L73X-
A.03.18

Official After Sales Network
Wheel badge upgrade
March 9, 2018
4

Wheel badge upgrade

1) Aventador Coupe and Roadster; 2) Aventador S Coupe and Roadster.

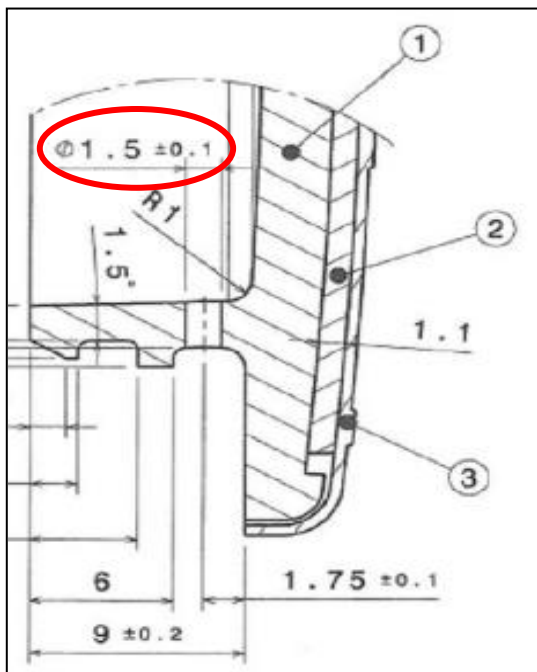
C. Drilling of the wheel badge.

- Follow the technical drawing specifications to make the 2 holes ($\varnothing 1,5$ mm) in the correct position of the badge (Space A in the figure).

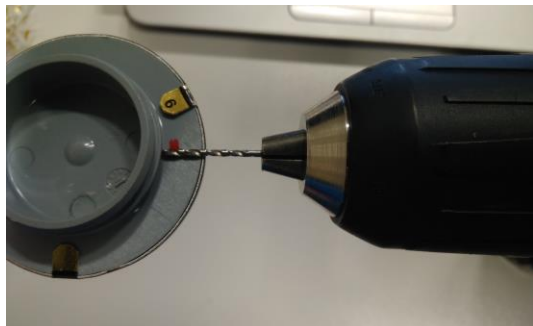
- To find the correct position of the holes Automobili Lamborghini recommend using the circled point in the image as a reference (in order to obtain two alligned holes). Using like a reference the circled point in the figure and mark the 2 points where you will need to drill the holes.

The points must be marked in the space A (see image below).

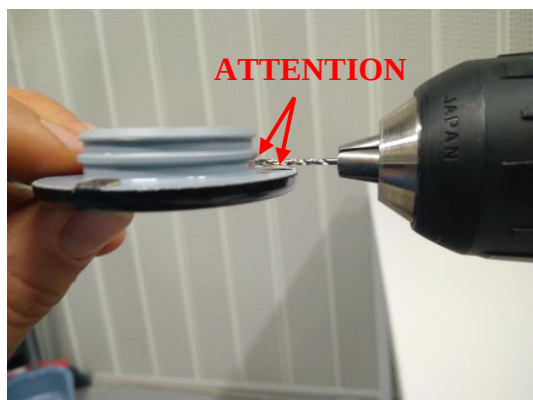
To avoid damaging of the badge, be careful not to touch the points shown in the following figure during the drilling operation.
